## Eastern Corridor Segments II and III

Combined Linwood/Eastern Interchange and US 50/Red Bank Interchange Focus Area

# US 50/RED BANK CONNECTIVITY

**Figure I-16B**  
**ROUNDBOUT AT MEADOWLARK LANE  
AND U.S. 50 INTERSECTION**

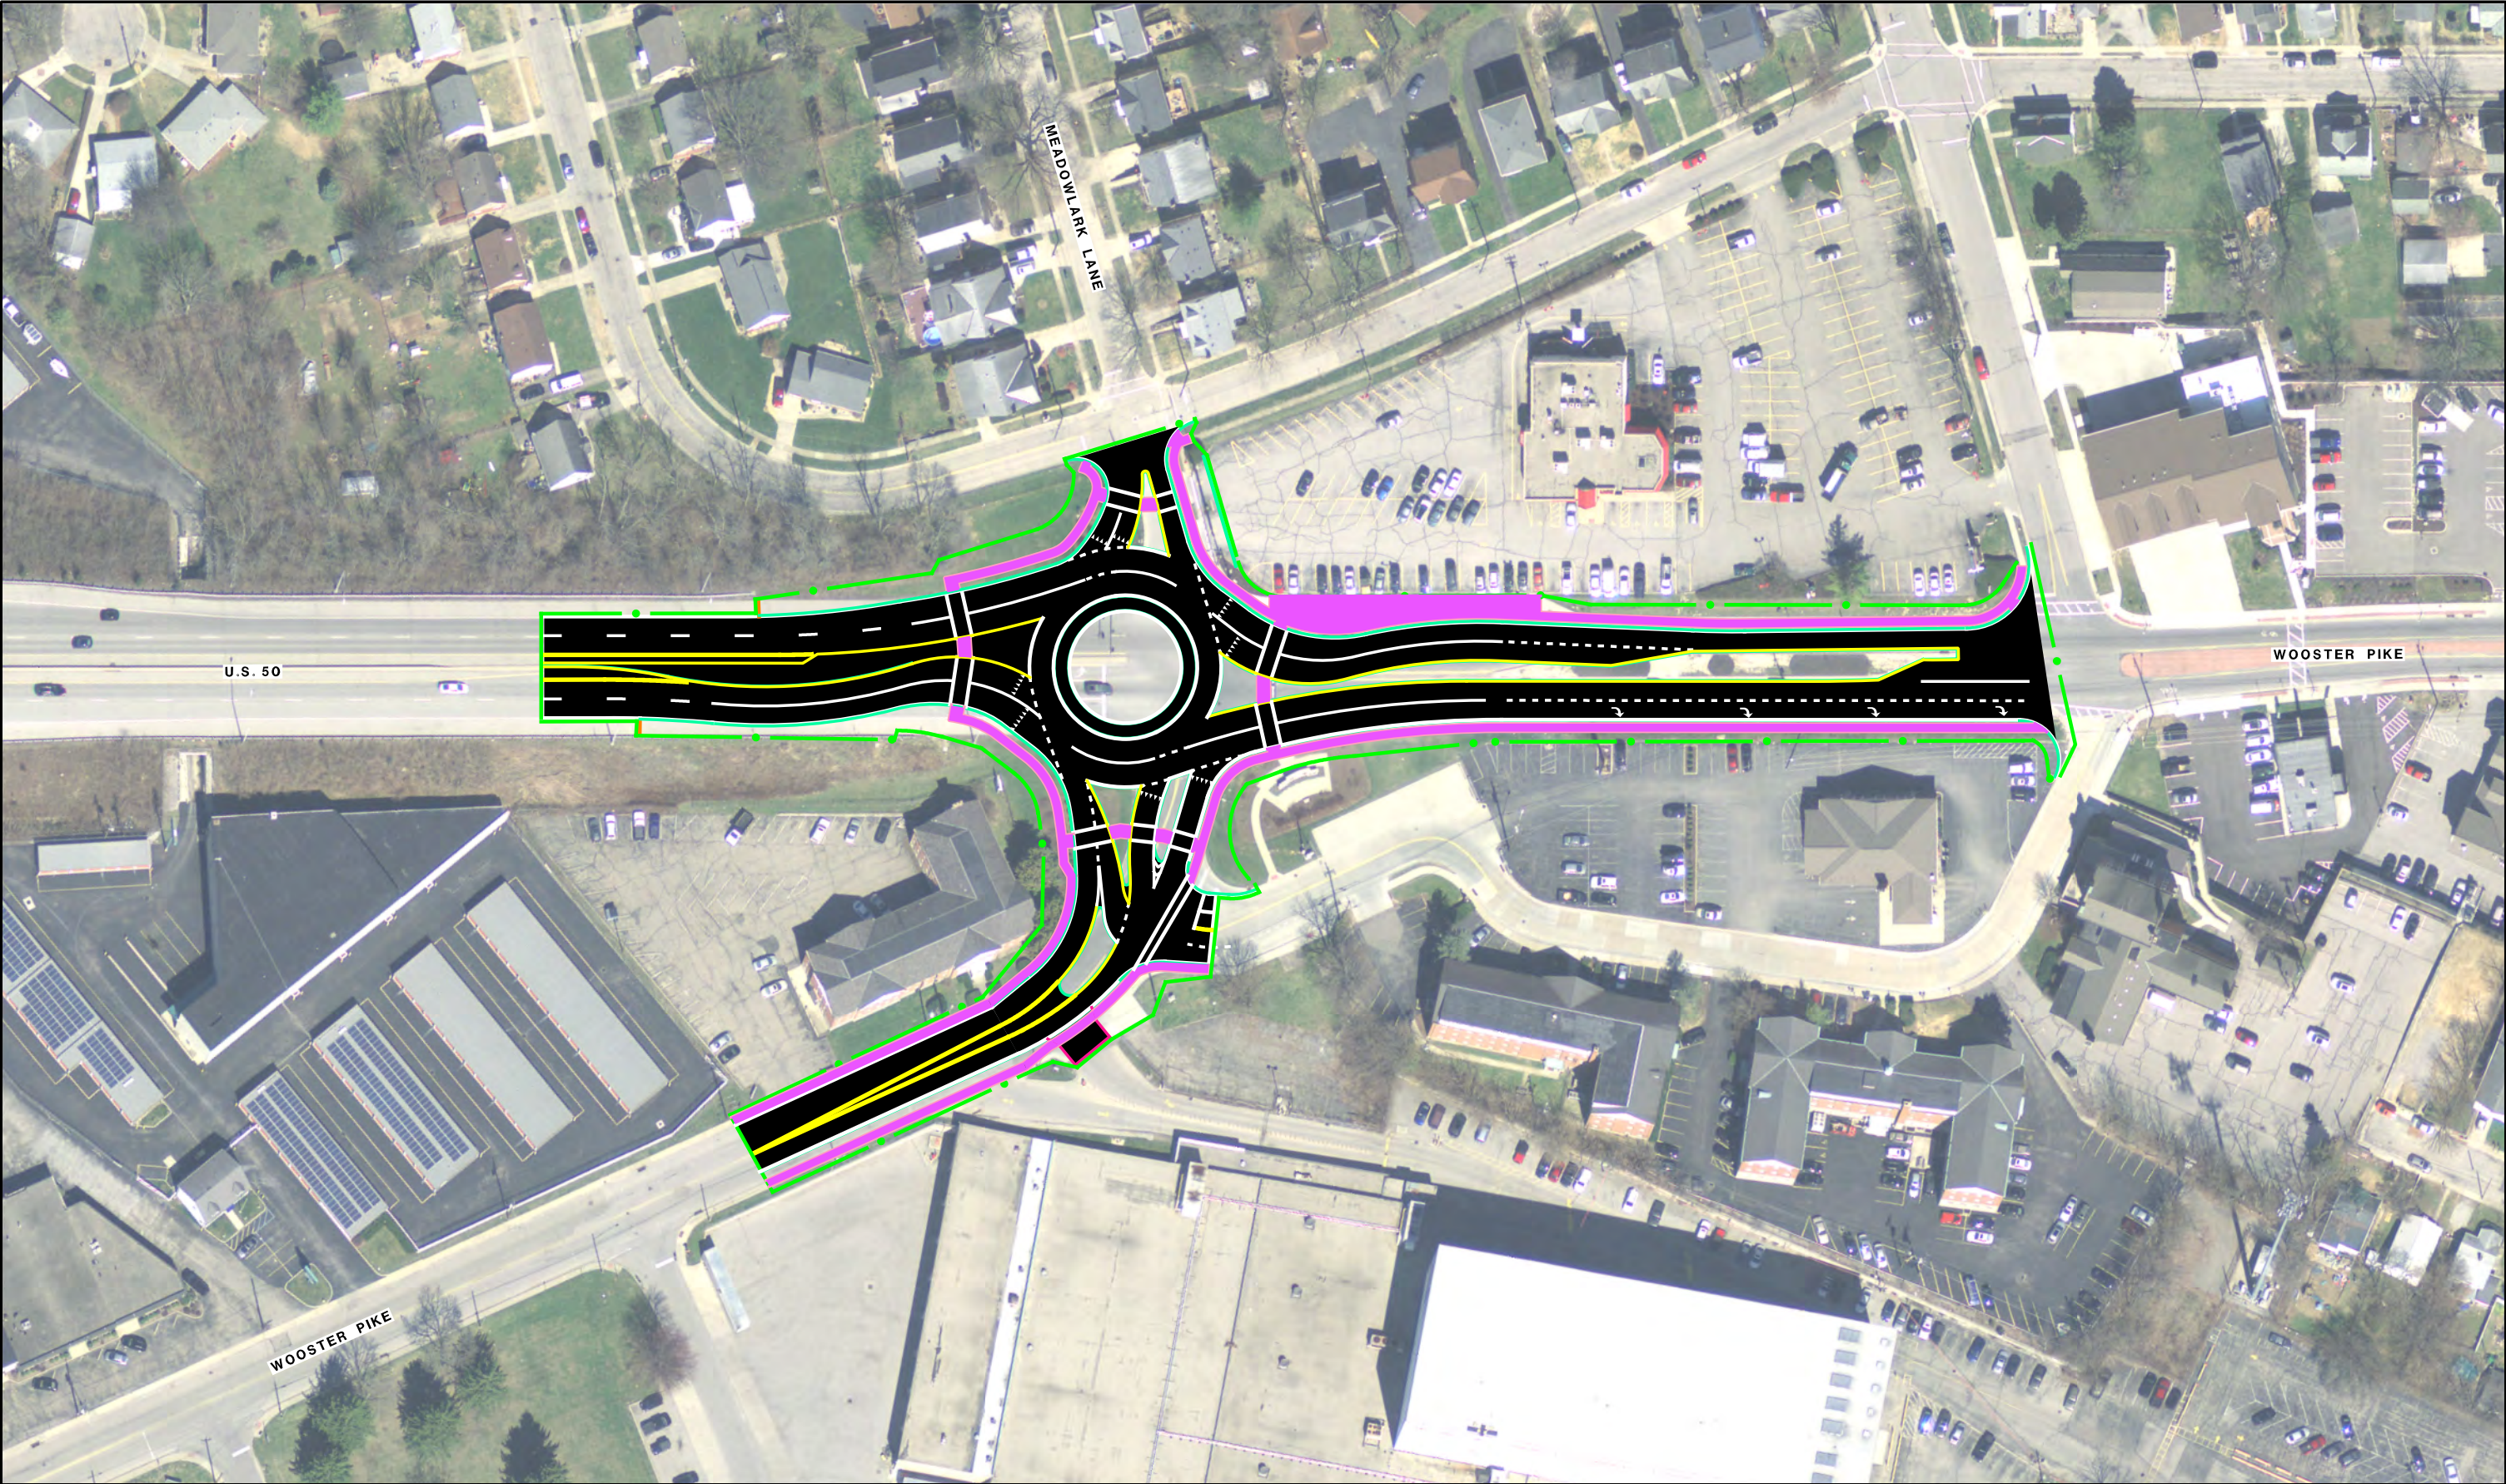
- Verify roundabout shown is drawn to scale and that it will accommodate life safety and semi-truck traffic. Have all other options for this intersection been eliminated? Additional input from Mariemont businesses will be needed to address other potential concerns. The

- The committee discussed whether the traffic signal at Watterson could back drivers up into the roundabout. Traffic simulations show that for 95 percent of queues, this would not be an issue. However, given signal timing adjustments and the fact that closures on Wooster Pike have resulted in more traffic on US 50, these simulations will need to be re-evaluated once Wooster reopens to ensure that is still the case.

- The committee discussed whether it would be simpler to reconfigure the lanes in front of the Mainliner and eliminate the curb bump-outs to allow for two lanes of westbound traffic. This could provide a more immediate solution, with the roundabout phased in later. Long term, however, the roundabout offers other benefits (slower travel speeds, increased safety) and could serve as a gateway to Fairfax.

- Public comment appears to be favorable toward the roundabout concept (see Public Feedback Ratings Summary, next page).
- There was some discussion about how the roundabout may impact the ability for vehicles to turn onto US 50 from side streets. ODOT/Stantec acknowledged that turning left onto US 50 during peak hours might be challenging.
- The committee agreed that the best approach going forward would be to implement other, lower-cost traffic improvement concepts first and evaluating their effectiveness before pursuing the construction of a roundabout at this intersection.

- Include concept in the Implementation Plan as a medium priority.
- Pursue implementation of signage improvements and adding advanced signal detection improvements first before advancing a roundabout at the Meadowlark/US 50 intersection.

**Figure I-20B**  
**ROUNDBOUT AT WOOSTER PIKE  
AND RED BANK ROAD INTERSECTION**

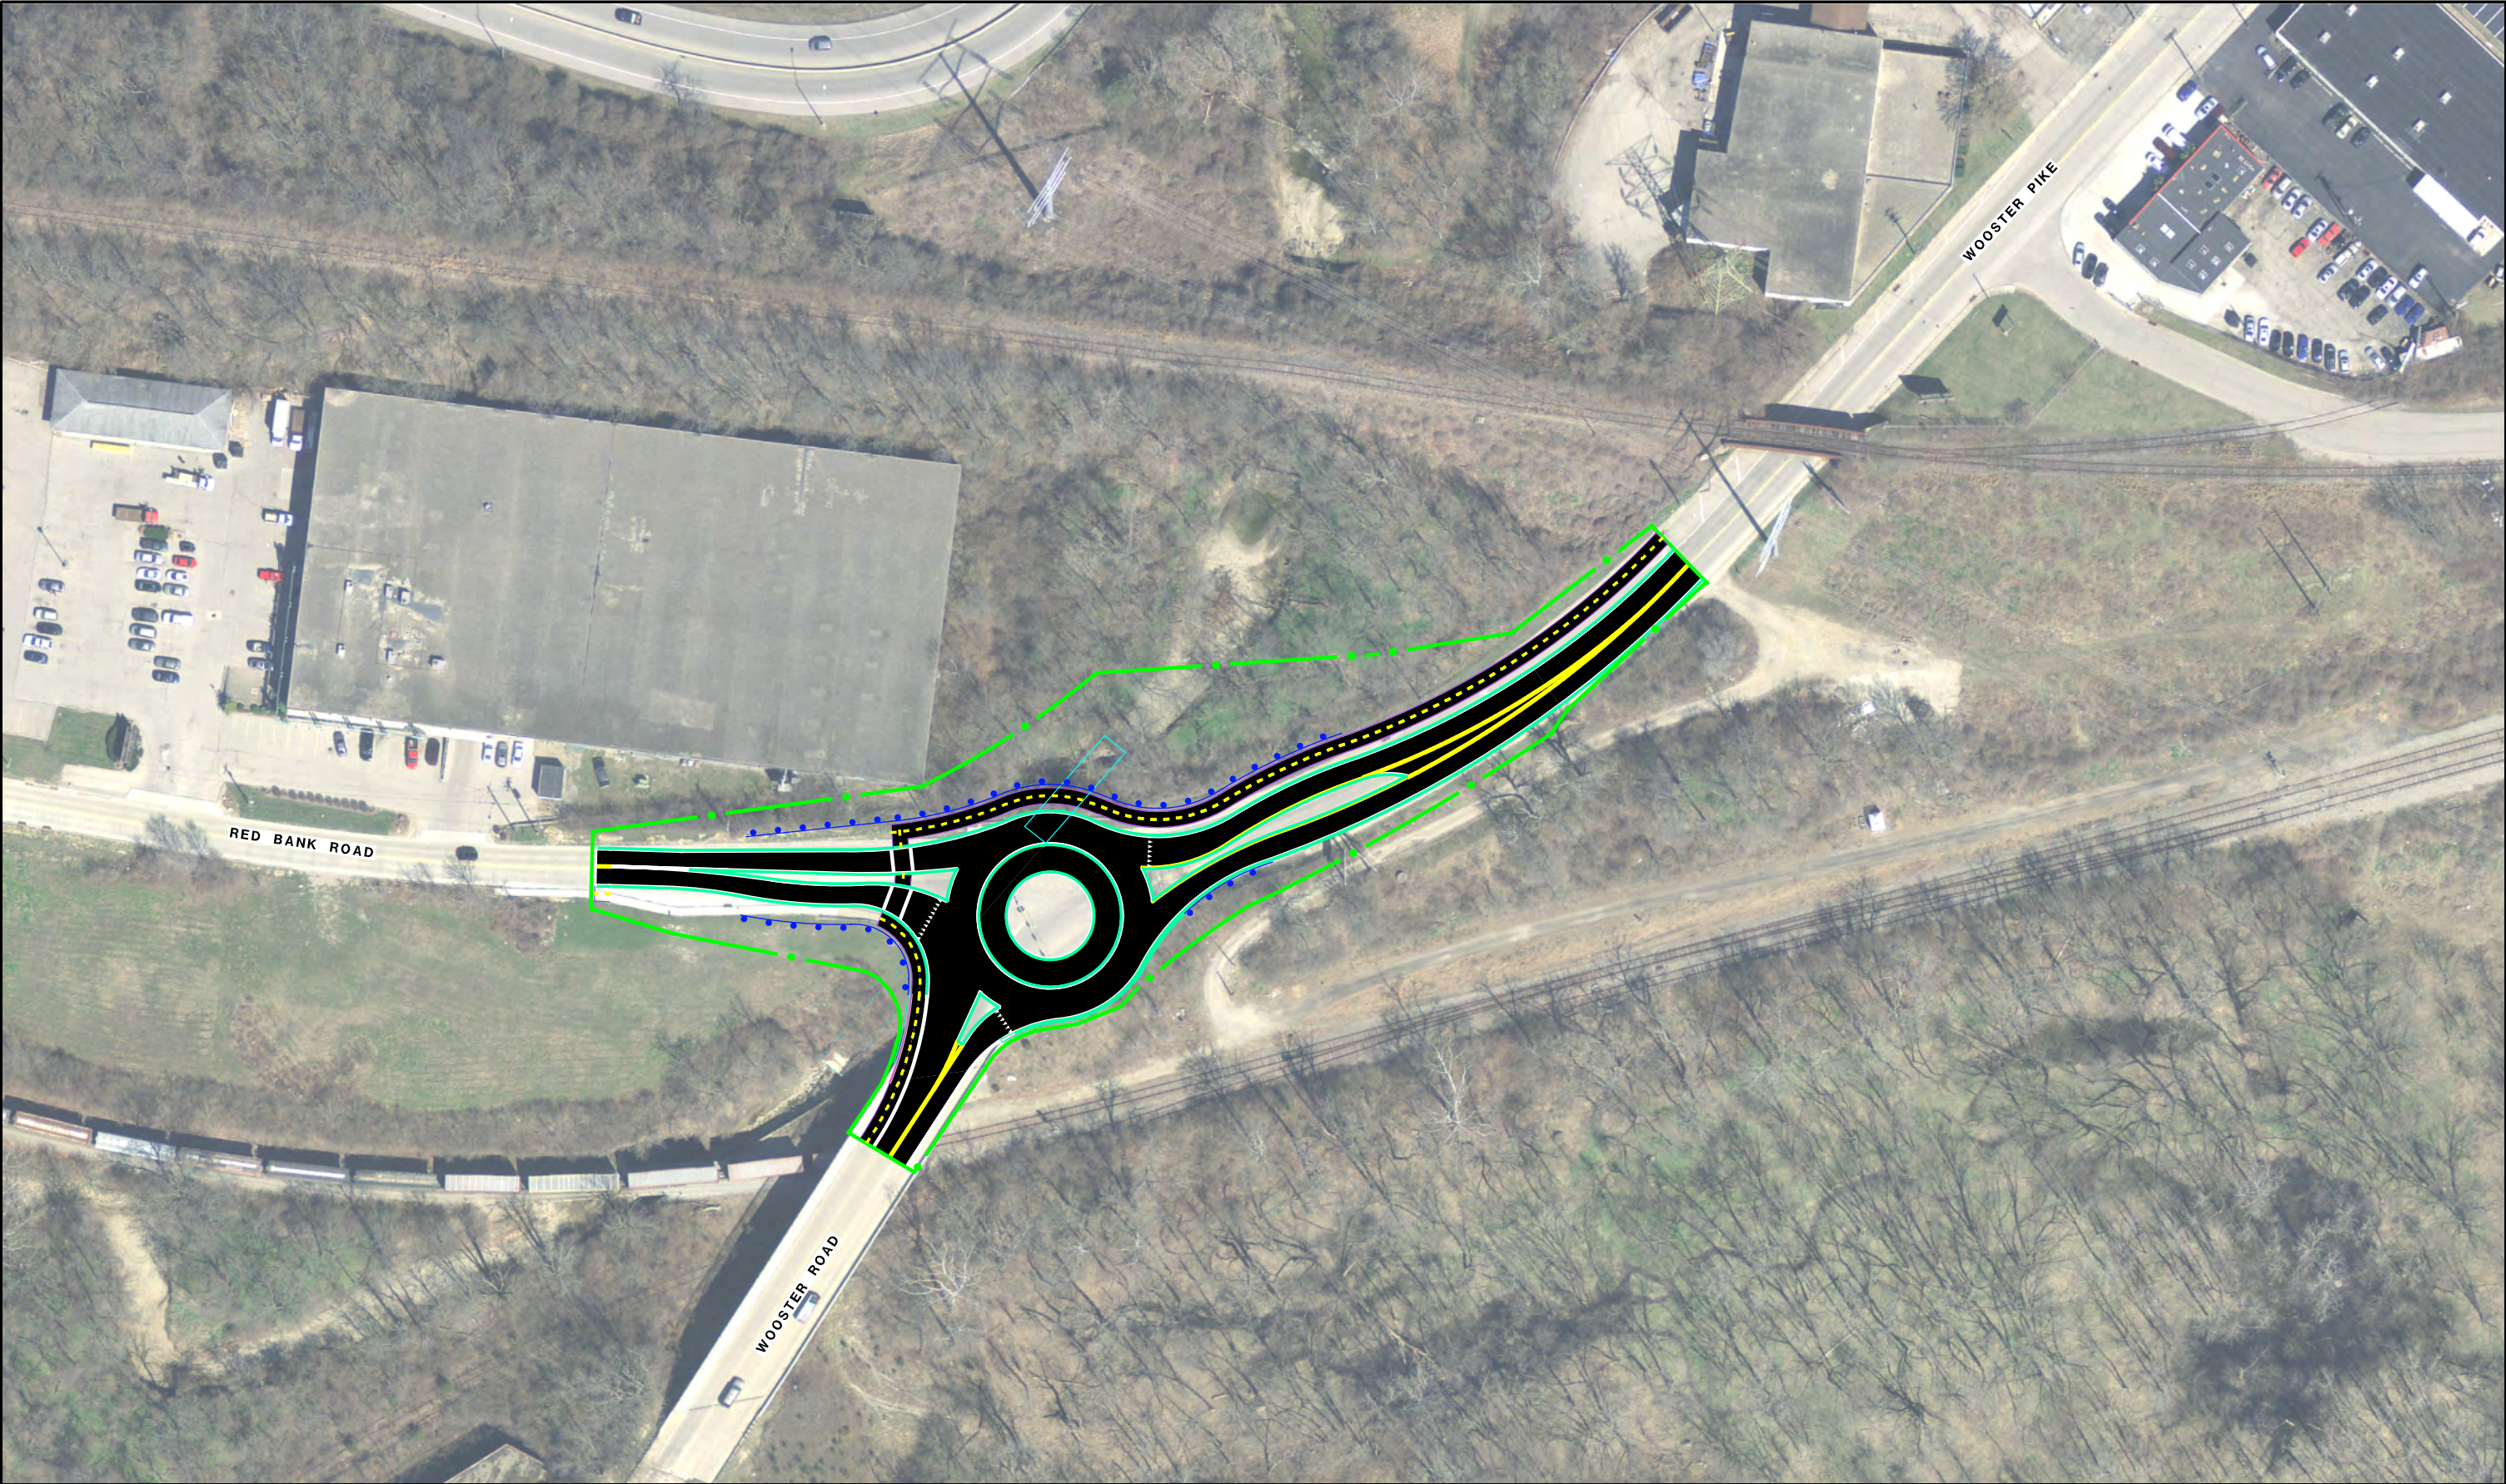
- A roundabout would be designed to comfortably accommodate trucks.
- Would only need to use two lanes instead of three on the bridge, and it would be possible to get a bike lane across the bridge over the railroad without widening the existing bridge.
- Initial analysis indicates:
  - No change in delays during morning peak-hours.
  - A 20 percent increase in delays during evening peak-hours.
- Team will consider how best to incorporate multi-use path connections into this concept.
- No additional comments received following the 5/22 meeting.

- In general, feedback received from the public on this concept was favorable (see Public Feedback Ratings Summary, next page).
- This roundabout wasn’t specifically proposed to address safety concerns; there are not a lot of accidents recorded in the area. Its purpose is to better manage traffic flow. It would also improve bicycle and pedestrian connections.
- The roundabout will be designed to accommodate truck use.

- Include in the Implementation Plan as a medium priority.
